**MPC Paper No. 8/17
For Consideration by the
Metro Planning Committee on 27.10.2017**

**Submission for Partial Fulfillment of
Approval Condition (a) under Application No. A/H15/232-2**

**Proposed Hotels in “Other Specified Uses”
annotated “Ocean Park” Zone, Ocean Park**

Checked	DH	Drawn	PW
Rev	0	Date	Aug 2017
Scale	Figure 3.10a

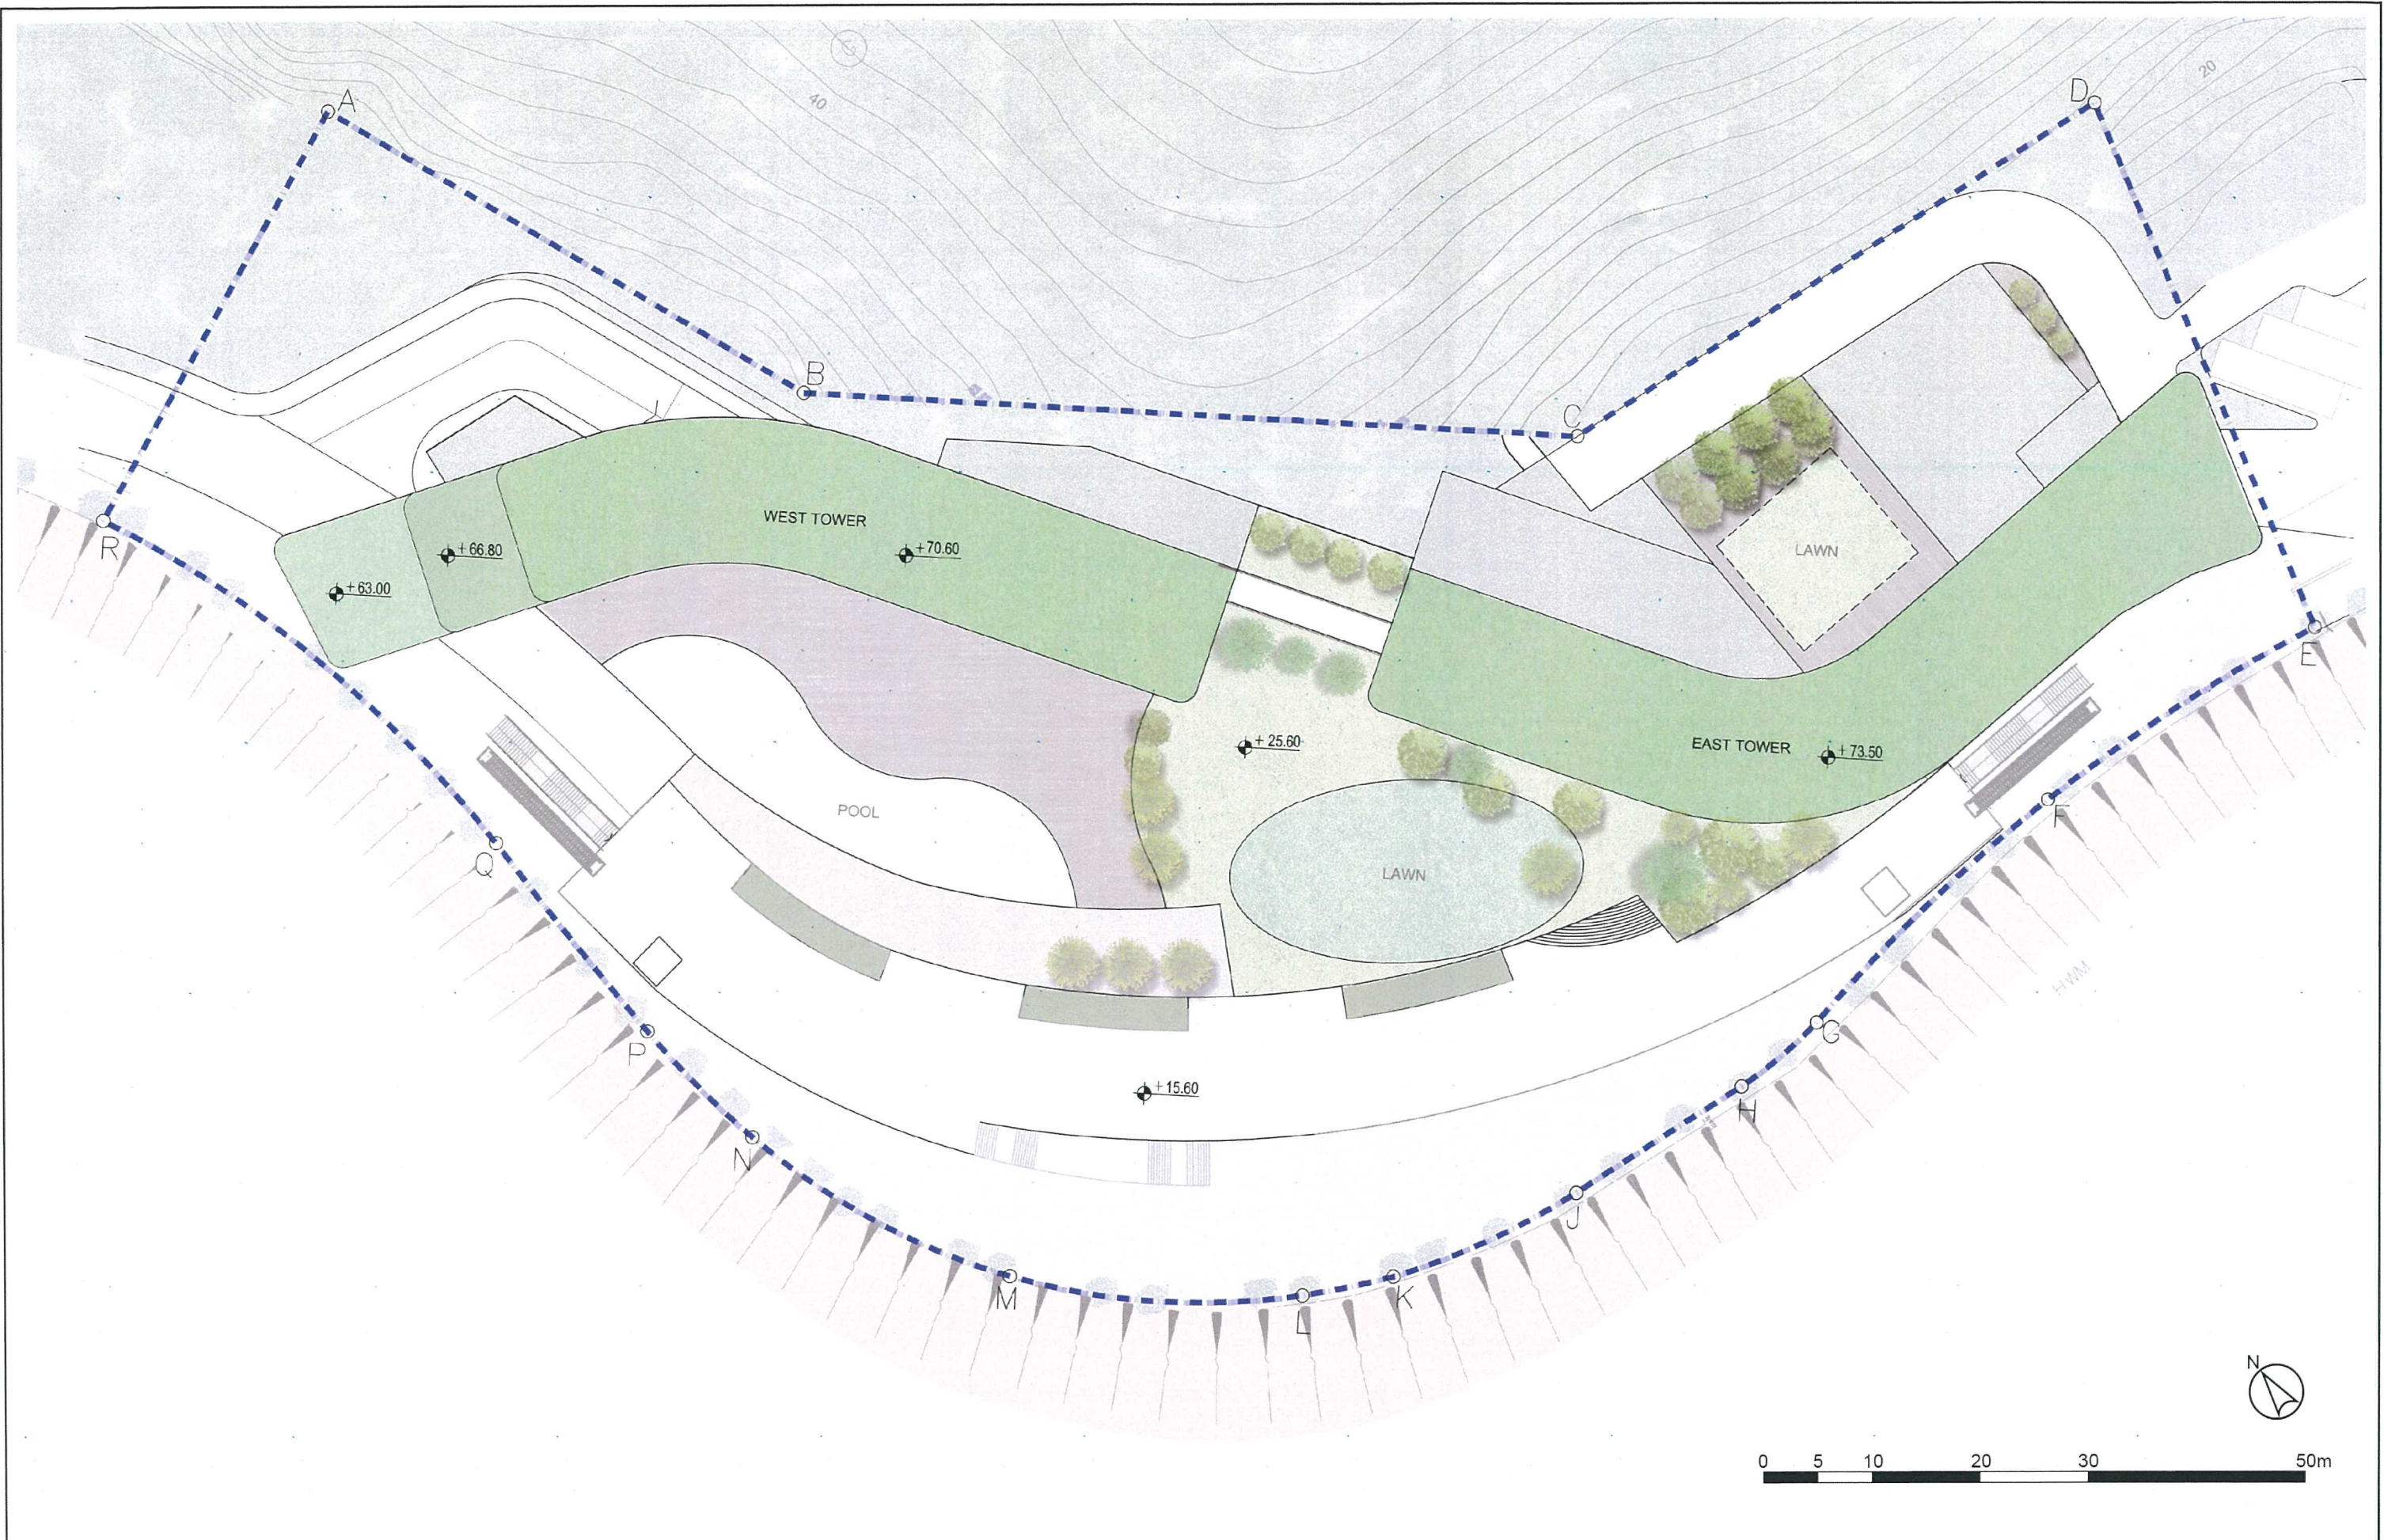
4.3	In Figure 3.10a, floor to floor height (8.5m) at G/F seems excessive. Please consult BD on this issue.	<p>With respect to the 2016 Approved Scheme, one of the major design merits of the Current Updated Scheme is to provide a waterfront promenade of not less than 10m at the 1/F with a covered driveway running beneath it. Such vehicular passageway also serves to connect the Ocean Park's Shum Wan Road Entrance and the Water World at Tai Shue Wan area via the proposed hotel.</p> <p>To satisfy the requirement under Building (Private Streets and Access Roads) Regulations and the requirement of Ocean Park, a minimum vertical clearance of <u>at least 5.1m</u> has to be provided for access roads / driveways intended for all types of vehicles. The stringent floor-to-floor height of 6.0m under the 2016 Approved Scheme would only allow a very confined space of less than 1m deep for structure and MEP facilities. Therefore, the revision of floor-to-floor height of 8.5m would provide a more reasonable space for engineering and servicing facilities. To optimise the use of G/F space, G/F high level may be utilised for MEP plants platform / mezzanine with necessary cat ladder / catwalk / access for future maintenance at subsequent detailed design stage. Please refer to the enclosed indicative diagram showing the G/F high level for reference.</p>

Indicative Comparison of 2016 Approved Scheme and Current Updated Scheme (VP4 – View from Vessels using Aberdeen Channel)

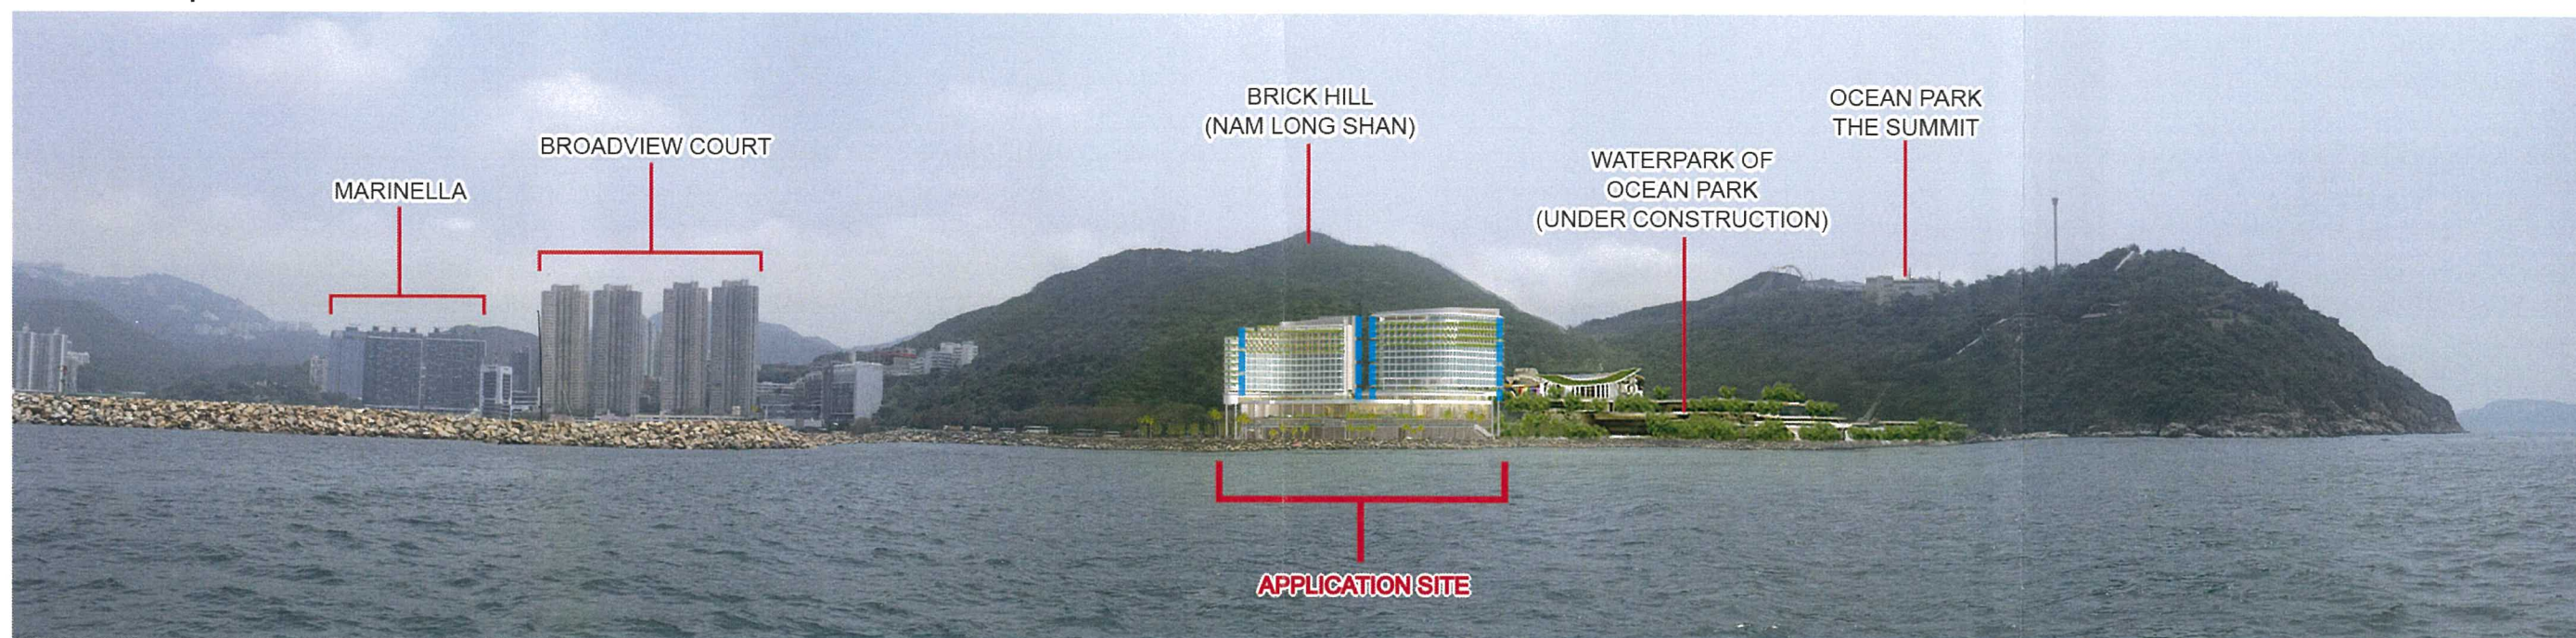
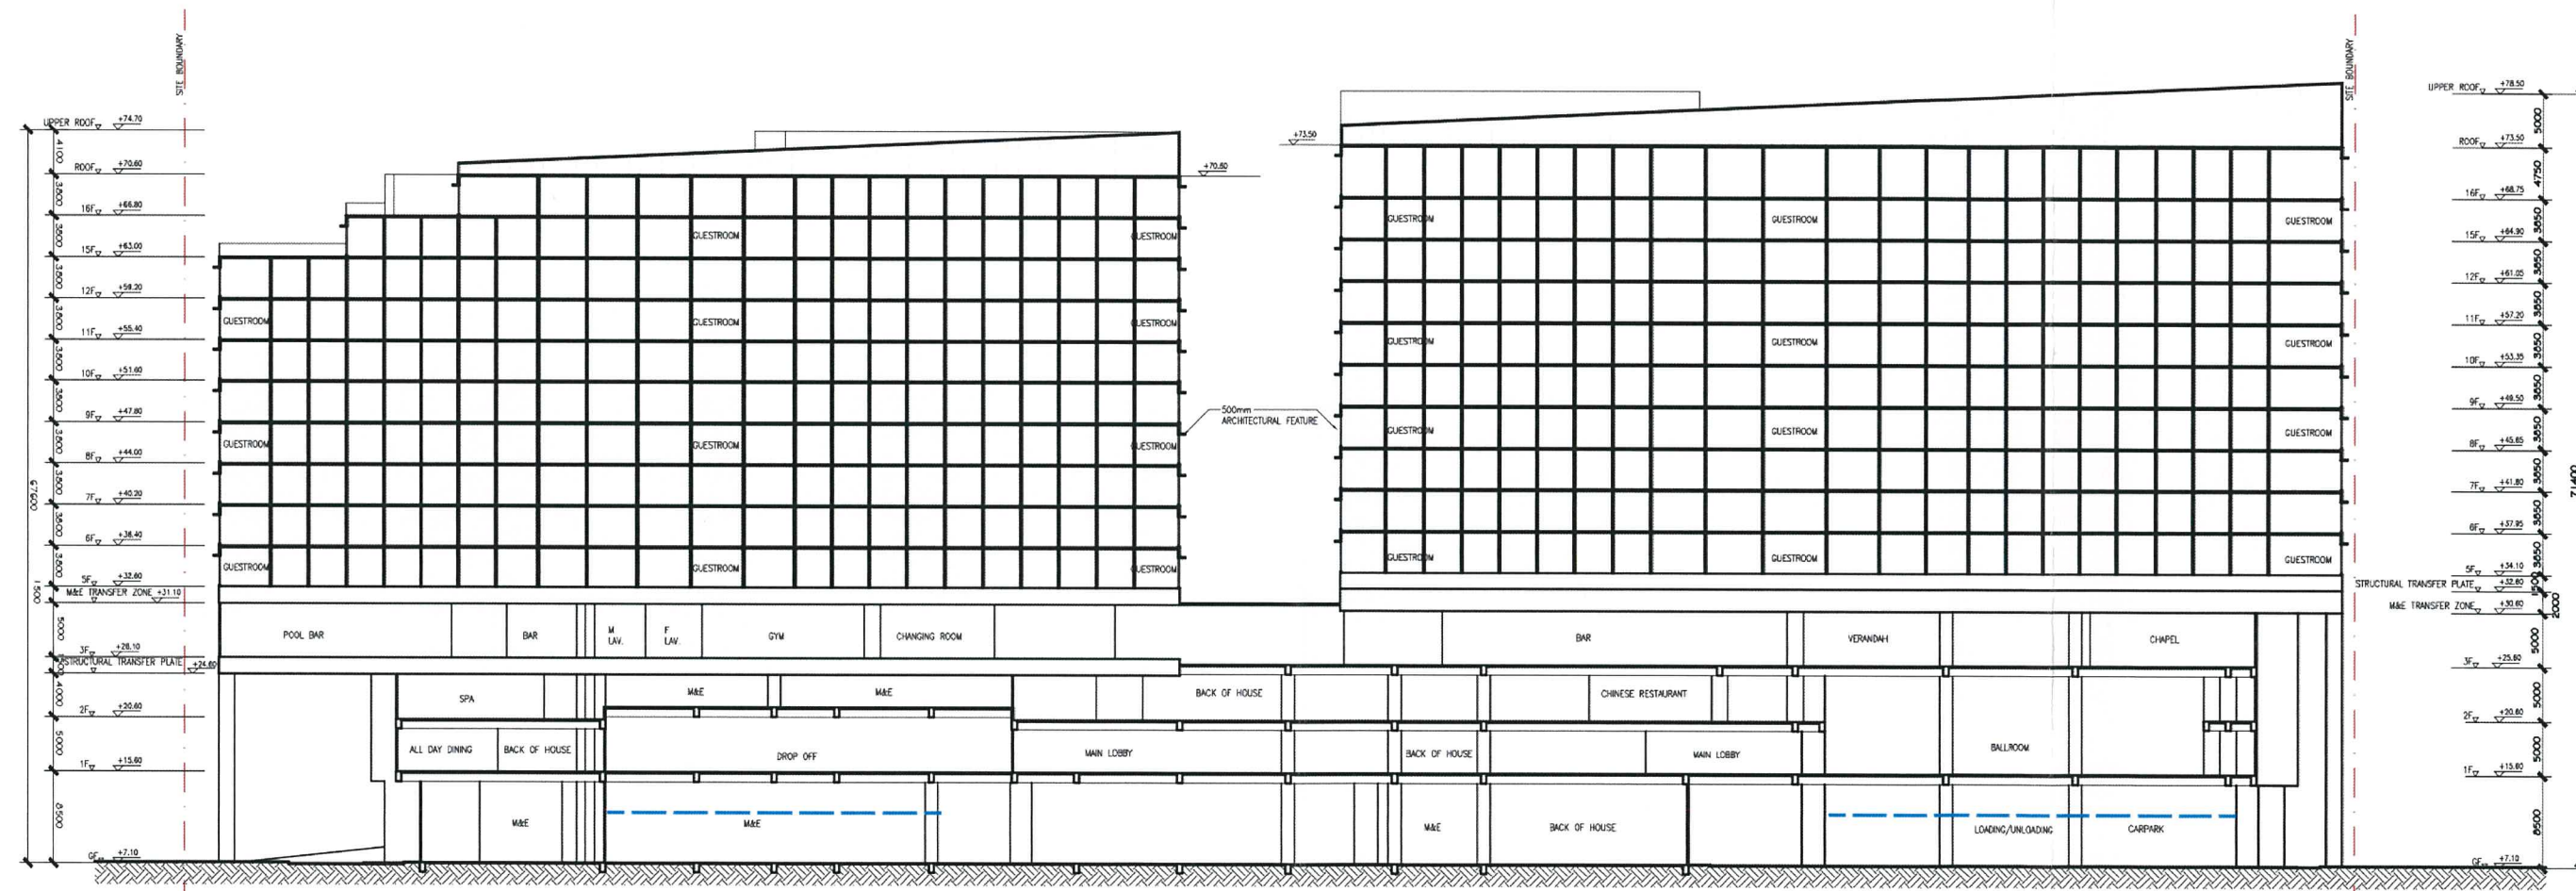
Departmental Comments	Responses to Comments
2.7	<p><u>Approval Condition (b): Submission of a Revised Visual Impact Assessment (VIA)</u></p> <p>Appendix C, Figure 4.4 – Under the current disposition and layout of the tower blocks, the western end of the tower should be perceived as further extending towards the west when compared with the 2016 Scheme. The consultant should review and revise the photomontage and relevant visual assessments, where appropriate.</p>	<p>The building block of the 2016 Approved Scheme and the Current Updated Scheme has been reviewed and compared on the enclosed illustrative diagram. As presented on the diagram, the resultant overall visual impact under the Current Updated Scheme is considered negligible / slightly adverse because:</p> <ul style="list-style-type: none"> • The magnitude of change in visual composition is considered minimal when viewing from the VP; • The visual permeability, major visual elements and visual resources will not be affected. The green mountain backdrop and the sky-view are largely retained under the Current Updated Scheme when viewing from this VP; and • The effects on public view at this VP is also negligible in view of the distance of this VP, the frequency of the vessels using Aberdeen Channel and the fact that the VSRs at this VP are transient in nature.

4.6	In Figures 3.12h and 3.12j, the building gap between the two towers is smaller and the overall building bulk is larger. The same is also observed in Figure 4.4. In view of the above and noting that there is a major vessel channel to the Aberdeen South Typhoon Shelter and Aberdeen Marina Club, enhancement measures to lessen the visual impact of the building should be considered.	<p>Please note that the 15m building separation between the East and West Tower has been maintained in the current scheme.</p> <p>A VIA has also been carried out to assess the possible visual impact as viewing from various angles near Aberdeen South Typhoon Shelter and Aberdeen Channel. As reflected in the VIA, similar to the 2016 Approved Scheme, the overall visual impacts of the Current Updated Scheme as compared against the existing condition would only be negligible or slightly adverse as the proposed hotel design is considered largely compatible with the existing visual context. Please refer to the submitted VIA (i.e. Appendix C of the submission dated 31 August 2017) for reference.</p>
